FINAL PLAT
DORE ADDITION
SEDGWICK COUNTY, KANSAS
2001

RE: SUB 2001-85 -- One-Step Final Plat of Dore Addition

CASE NUMBER: SUB 2001-85 -- DORE ADDITION

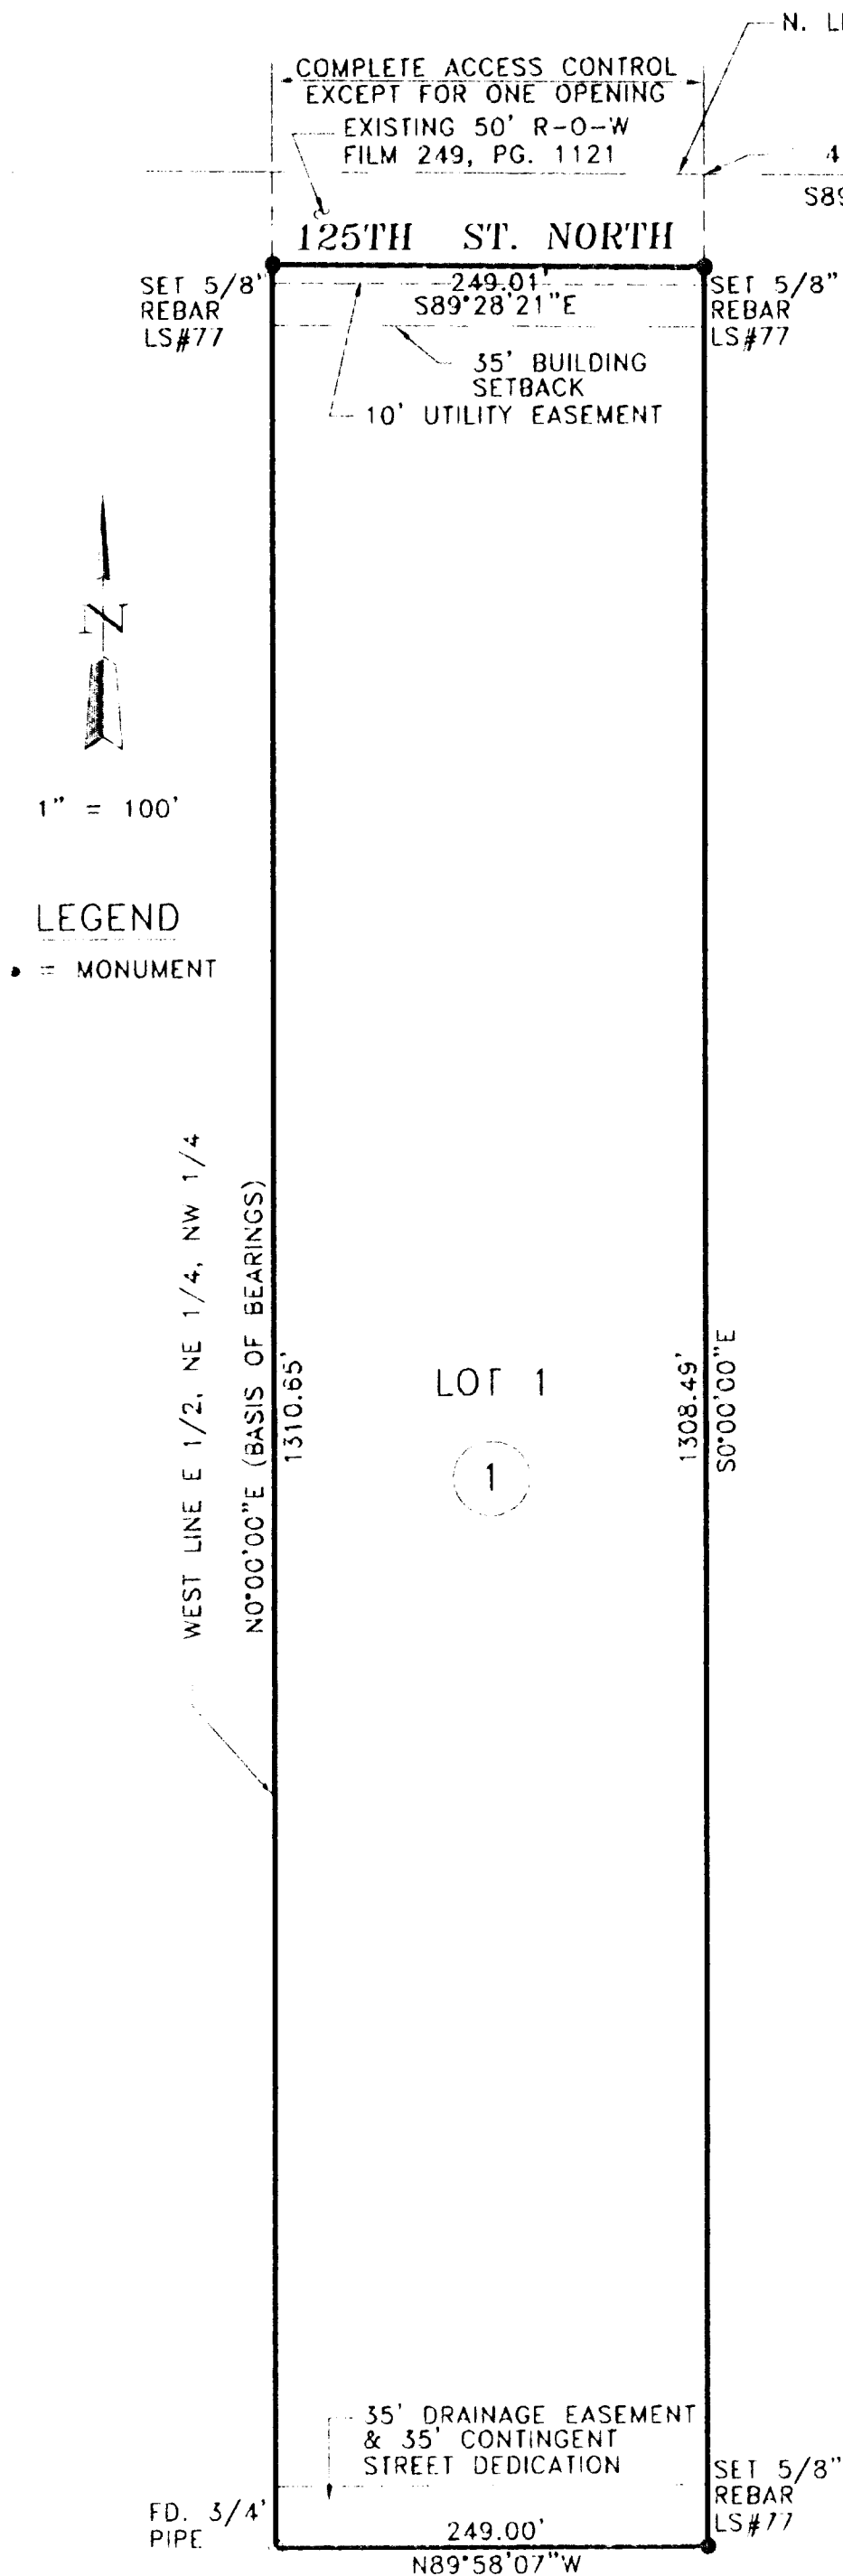
- C. **County Engineering** needs to comment on the status of the applicant's drainage plan. **A drainage plan and lot grading plan is needed.**
- D. The Applicant should provide an off-site 35-ft contingent dedication of street right-of-way along the east property line of his adjoining property to the east in order to provide potential street connection to adjoining properties. This dedication shall be established by separate instrument.

- E. The plat proposes one access opening along 125th St. North. **The Subdivision Committee has approved the access controls.**
- F. The signature line for the County Commissioners need only reference "Carolyn McGinn".

- G. The Applicant is advised that if platted, the building setback must be increased to 35 feet to conform with the Zoning setback standard for County section line roads.

- H. Approval of this plat will require a waiver of the lot depth to width ratio of the Subdivision Regulations. The Subdivision Regulations state that the maximum depth of all residential lots shall not exceed 2.5 times the width. The Subdivision Committee has approved a modification.

- I. The Applicant has provided a pipeline easement agreement which appears to indicate a blanket easement for the area involved in this plat. The Applicant shall either obtain a release of this easement or provide proof that the easement has been confined. If confined, any portion of this easement impacting this site shall be denoted on the plat and shall be properly referenced. A recorded copy of the release/confinement of the easement shall be submitted.

- K. The plat's text shall include language that a drainage plan has been developed for the plat and that all drainage easements, rights-of-way, or reserves shall remain at established grades or as modified with the approval of the applicable City or County Engineer, and unobstructed to allow for the conveyance of stormwater.

- R. Recording of the plat within thirty (30) days after approval by the City Council and/or County Commission.
- S. The representatives from the utility companies should be prepared to comment on the need for any additional utility easements to be platted on this property. Southwestern Bell has requested additional easements.
- T. The applicant is reminded that a disk shall be submitted with the final plat tracing to the Planning Department detailing this plat in digital format in AutoCAD. This will be used by the City and County GIS Department.
